ALABAMA DEPARTMENT OF TRANSPORTATION

Re: **Response to the ADEM Review Comments: Site-Wide Corrective Measures
Evaluation**, dated April 25, 2008
Coliseum Boulevard Plume Site
Alabama Department of Transportation
Project Fund: 348-211-9273

ALDOT Responses to ADEM Comments
CME Comment Letter Dated April 25, 2008

NORTHWEST-SOUTHEAST GEOLOGIC CROSS-SECTION D-D';
COLISEUM BOULEVARD PLUME; MONTGOMERY, ALABAMA.

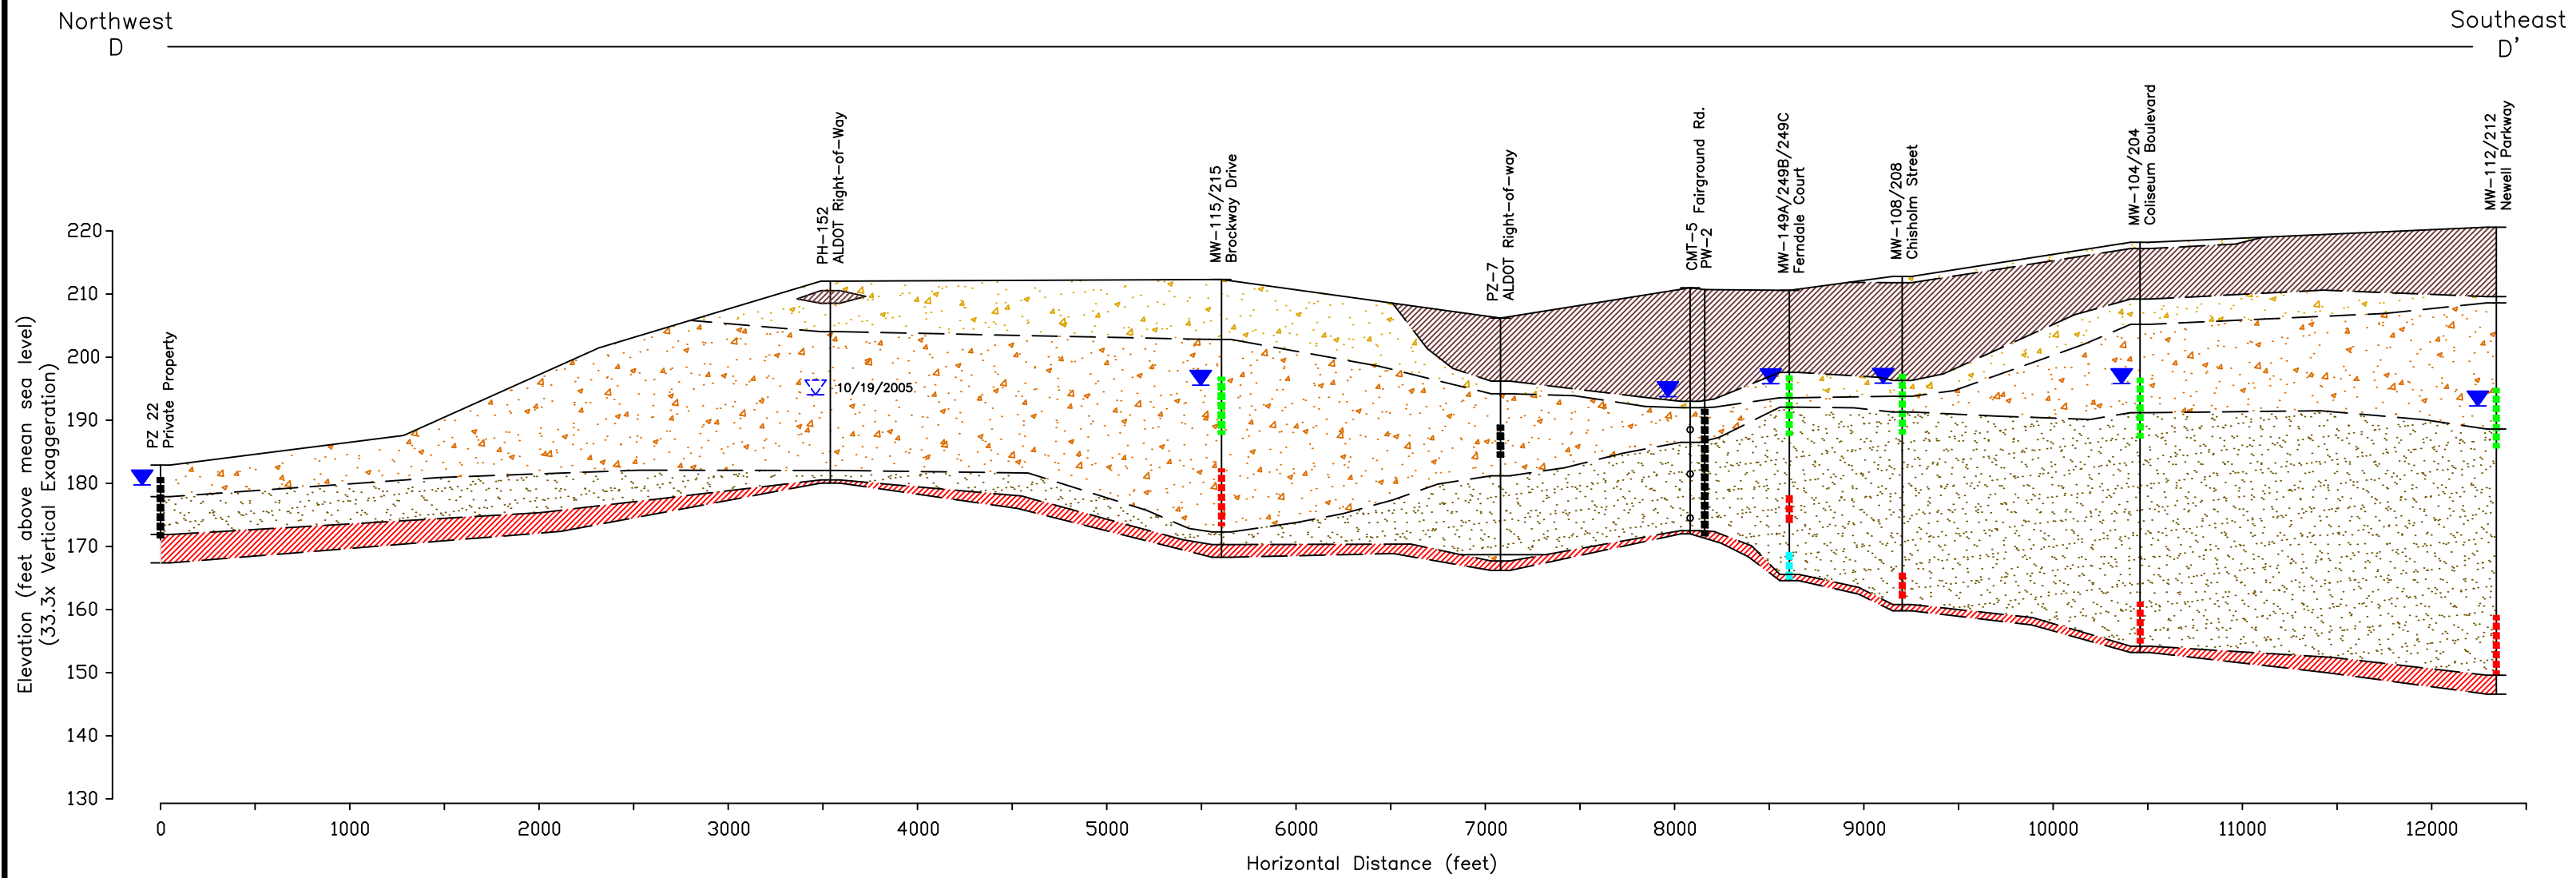
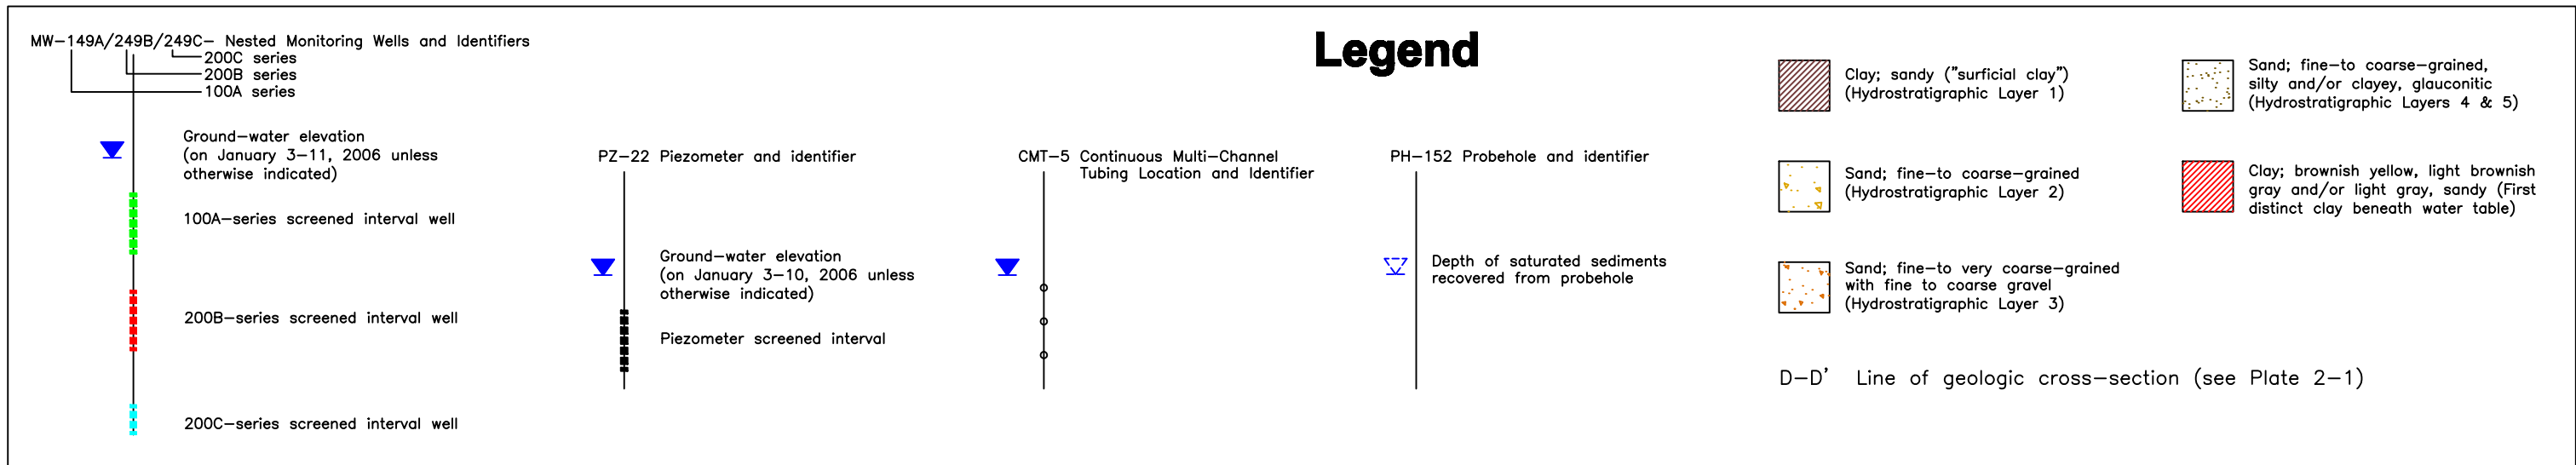
11. *Figure 2-16. Please clarify why the first distinct clay beneath the water table is represented by a dashed line between Brockway Drive and Ferndale Court.*

The original interpretation shown on the cross-section in the CME originated from the 2002 Conceptual Geology Report. The cross-section has been updated with boring logs for sites CMT-5, PW-2, and PZ-7 which coincide scale-wise with the original line of cross section. The geological information from these borings was used to eliminate the inferred line that was on the Figure 2-16. A revised Figure 2-16R is included.

FIGURE 2-16 R

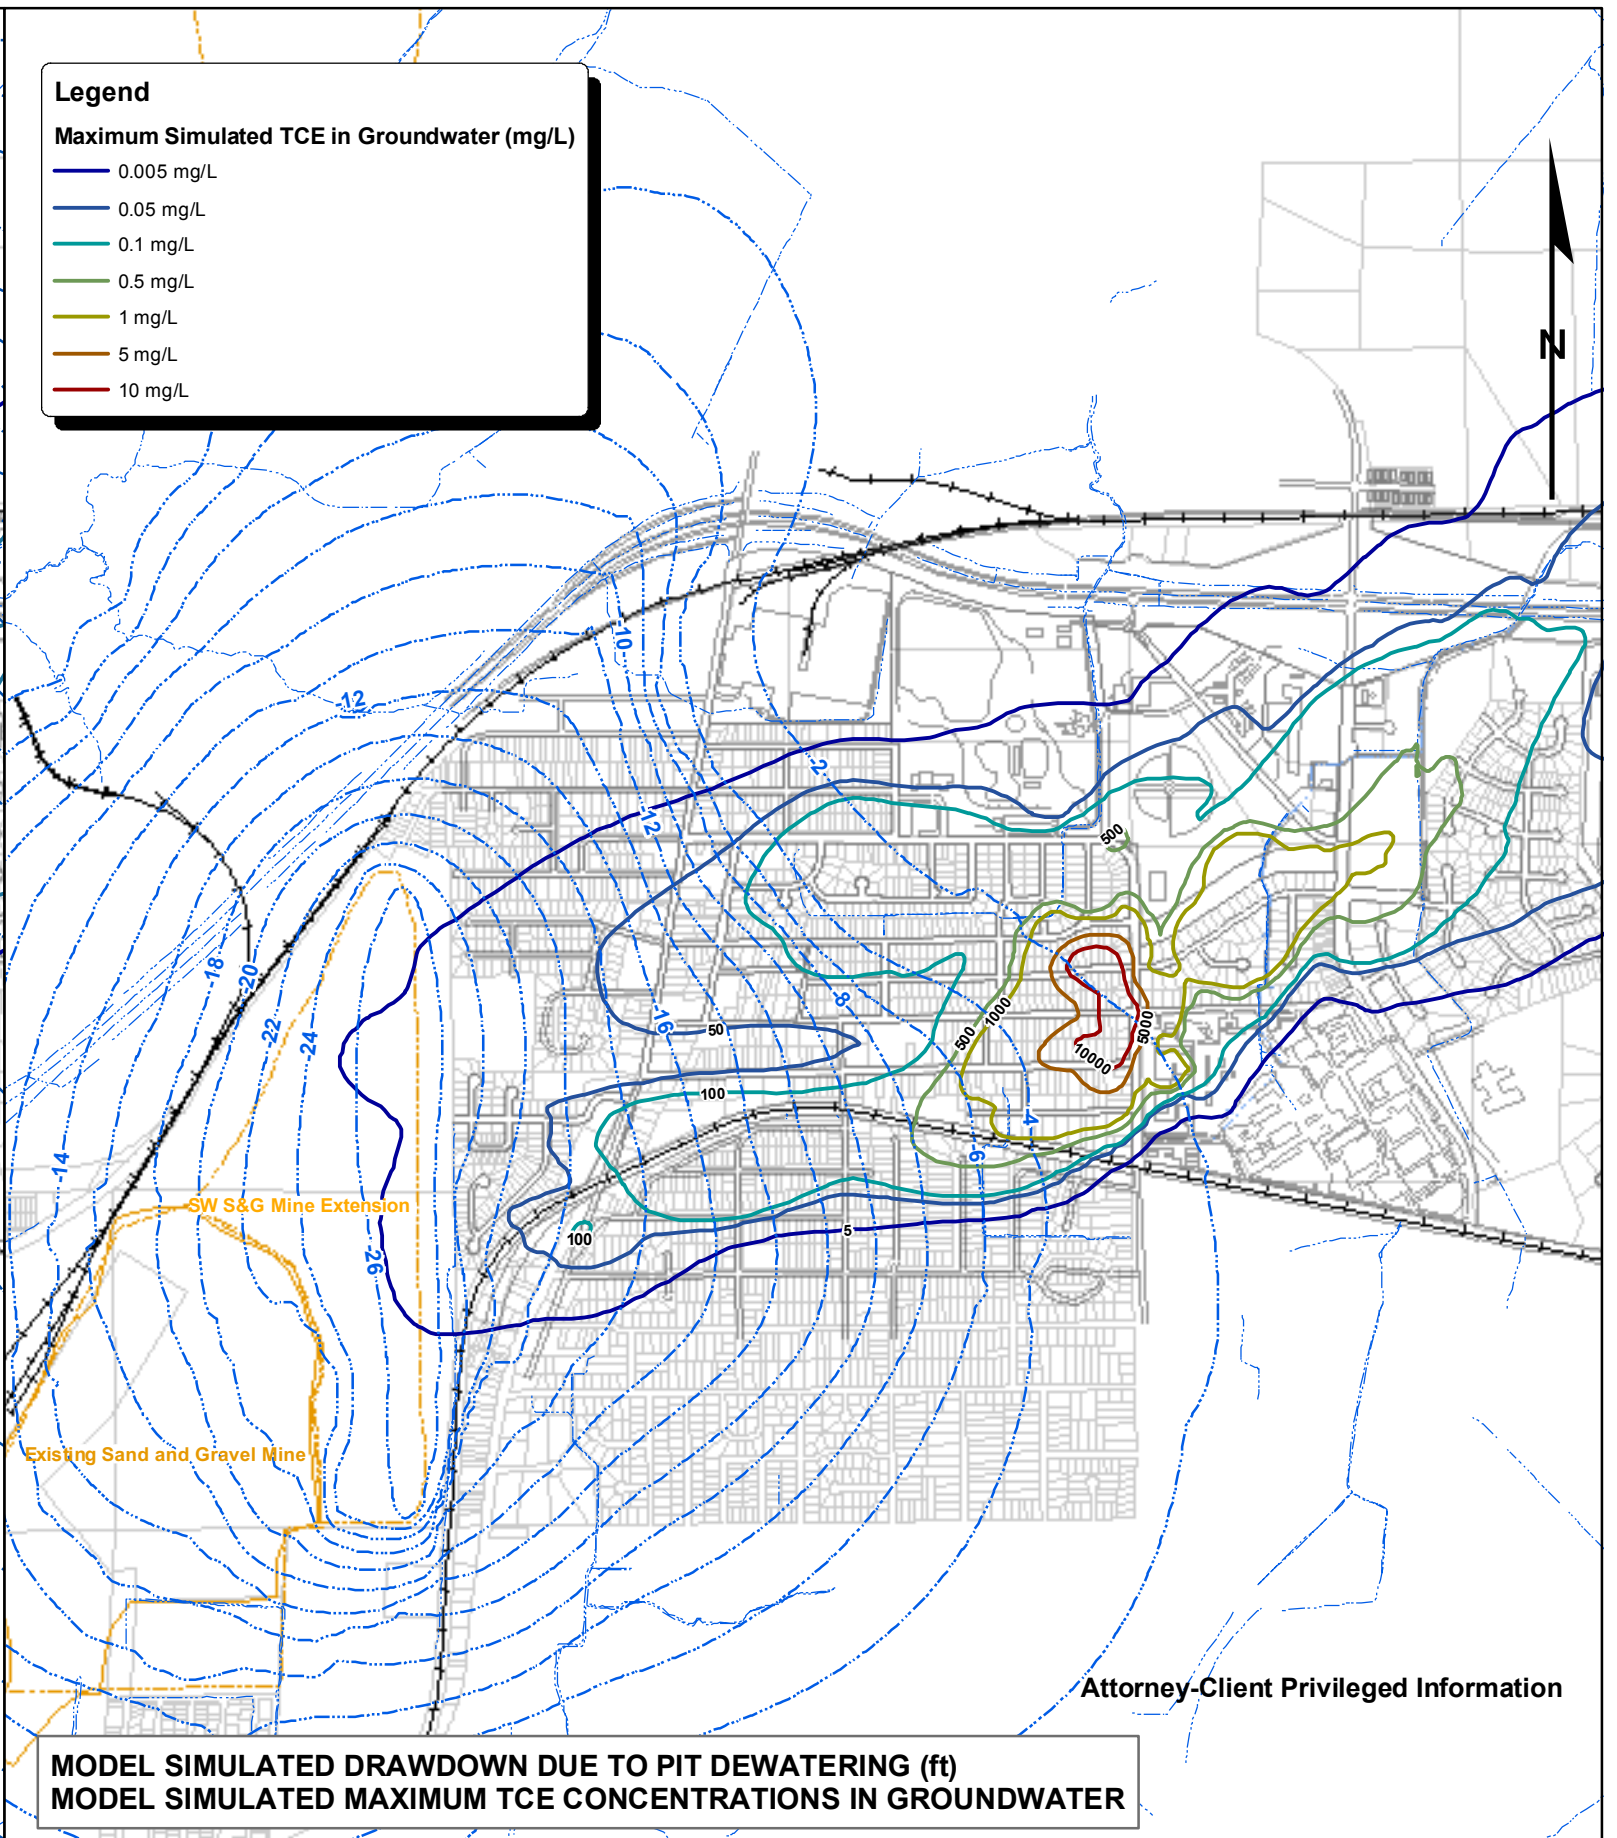
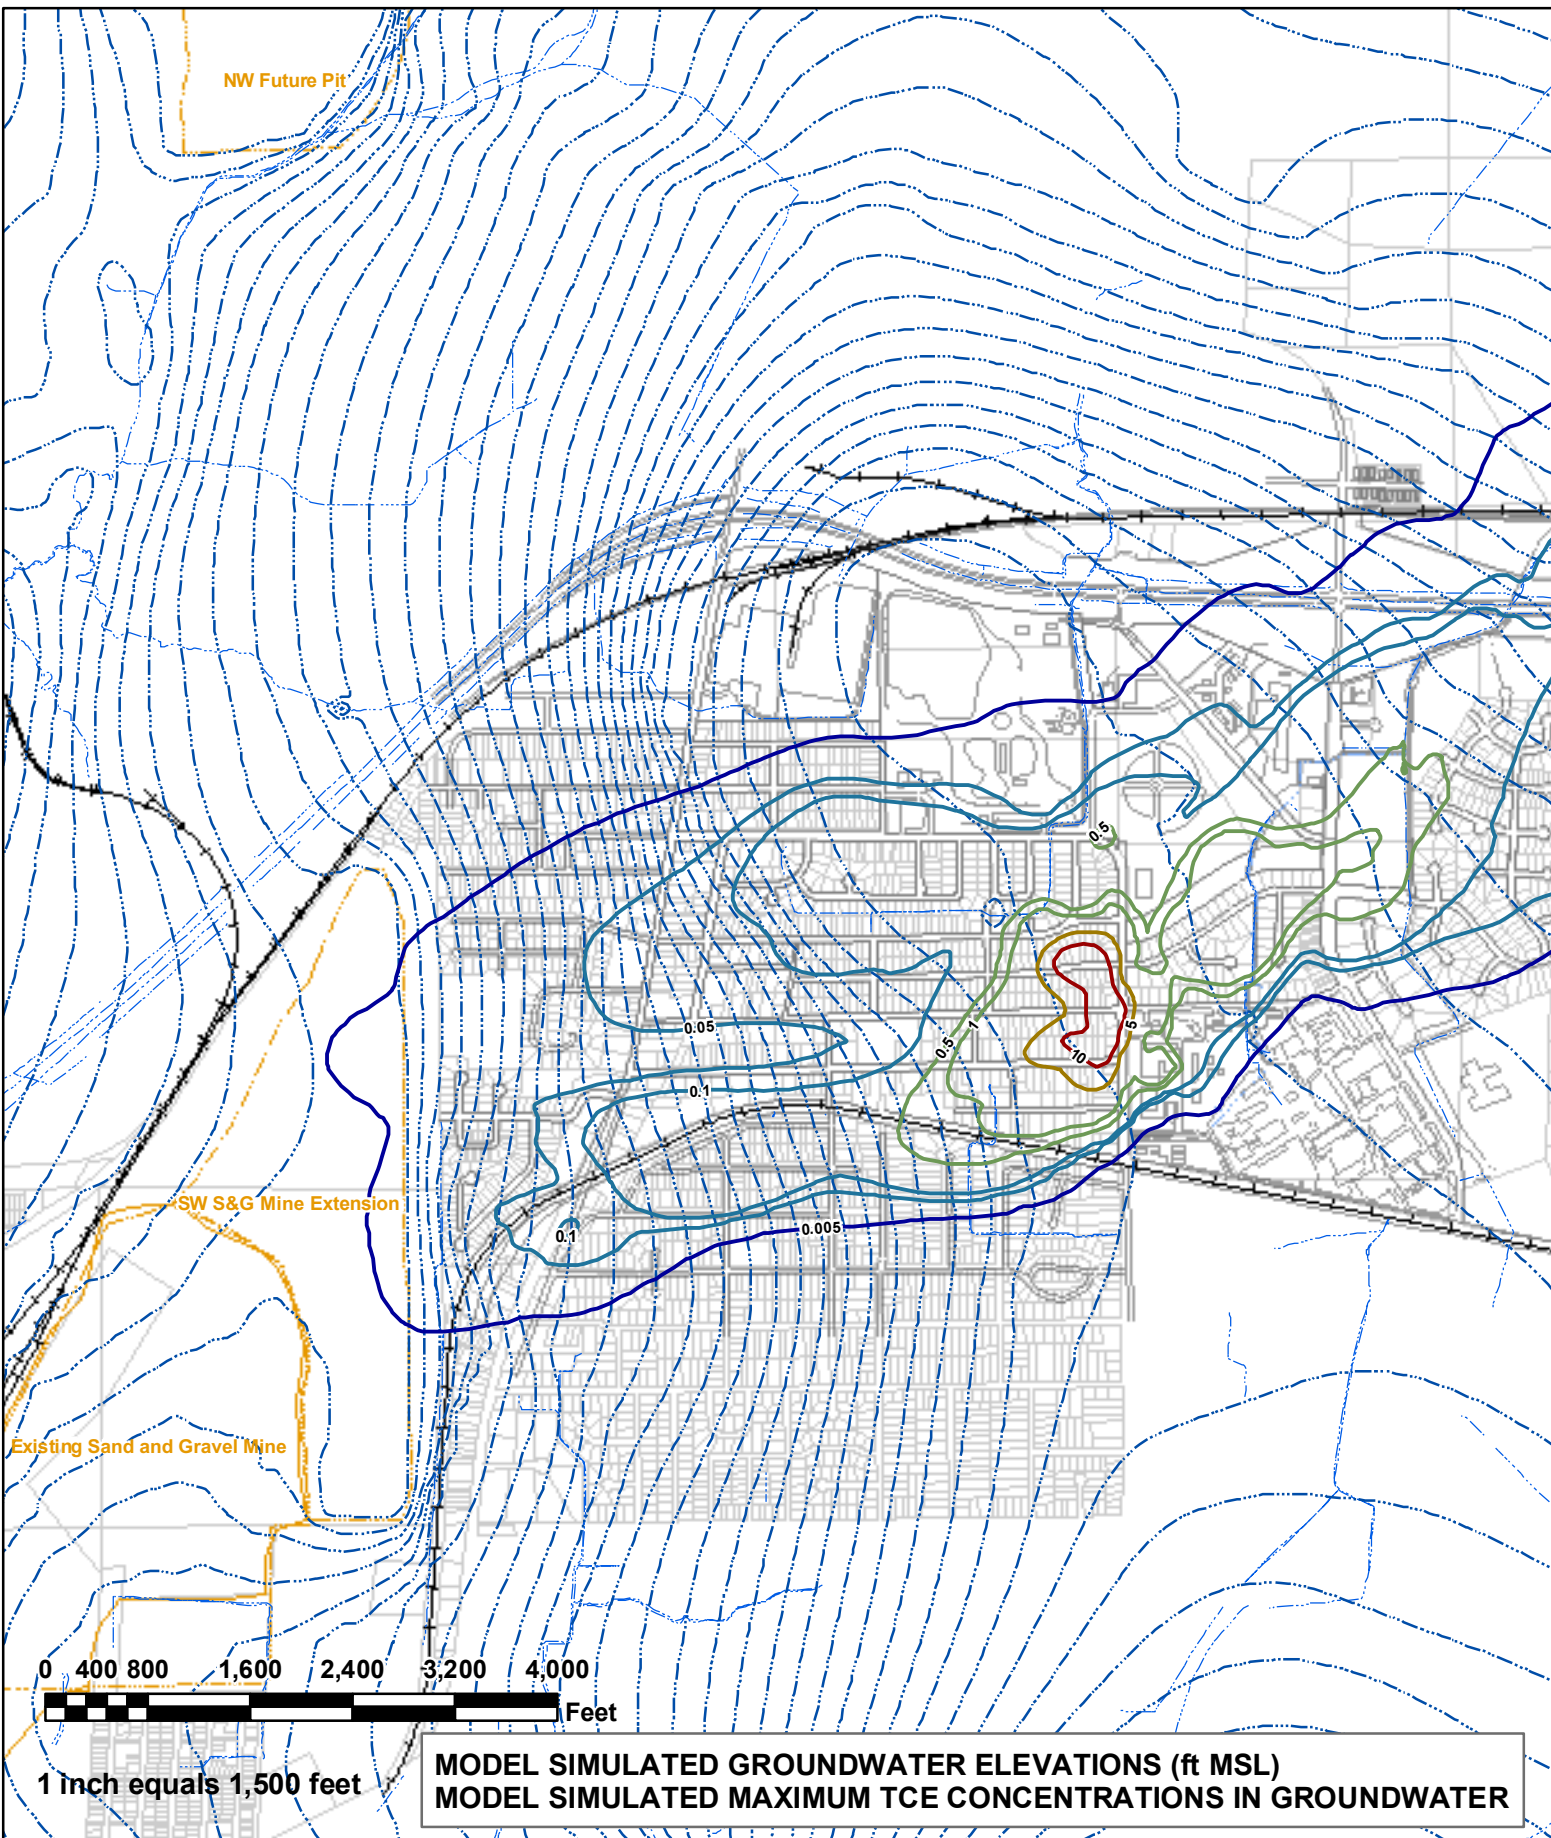
4. **Figure 2-16.** *The plume should be vertically delineated. Because TCE is a DNAPL and the site geology is predominantly sand and gravel the highest concentrations of TCE and free product will be found along the lower confining layer. The clay layer underlying most of the site, referred to as “the first distinct clay,” is a very thin layer; approximately 1-3 feet thick. It is possible that this clay layer is permeable or even discontinuous in some areas. A similar thin clay layer occurs on the Maxwell AFB site and has been proven to be discontinuous. Data from multilevel wells suggests that the greatest concentrations of TCE in the probehole 12/CMT 1 area are deeper than the screened intervals of the monitoring wells. It does not appear that any wells were completed at the lower confining layer in the area near CMT 1 and PH L6. Additionally, the Eutaw Aquifer is considered the source of recharge for the Gordo Aquifer in this region, despite the Gordo Aquifer being somewhat confined by the Gordo Clay. Please revise the report to address this issue.*

A “Deep Zone” Assessment of PH12 Area was completed in 2003 and found that “Based on the thicknesses of the first distinct clay penetrated at the boreholes of the deep-zone monitoring wells, the first distinct clay immediately beneath the shallow zone of the PH12 area, should provide a barrier to vertical migration of TCE into the deep-zone within the PH12 area.” Subsequent to this early investigation, numerous additional probeholes and wells were completed in the PH12 area and the findings did not conflict with the conclusion in the 2003 report. In addition to the extensive investigations to delineate the vertical and lateral extent of TCE in the PH12 area, an investigation specifically designed to investigate the potential for DNAPL was conducted in 2004 and 2005. As part of this DNAPL investigation, a membrane-interface-probe, with extensive sediment and groundwater verification sampling, was used to search for residual free-phase TCE (i.e.,DNAPL) throughout the Probehole 12 area. Numerous probeholes were driven to the first distinct clay, which was detected with a soil-conductivity probe that preceded the detector of the membrane-interface-probe. No free-phase TCE was detected in the samples or by the probe. An additional figure (Figure 2-12A) has been added to the CME to depict the vertical evaluation of TCE in the probehole 12/CMT 1 area and the report has been revised to state that vertical delineation has been completed in the probehole 12/CMT 1 area.

Section 2.4.2.2 has been revised to clarify that the vertical distribution in the shallow zone has been completed and that TCE is absent in the deep zone. A revised Figure 2-16R is also included. A new figure 2-12A is also included that shows all deep zone monitoring points on a separate figure.
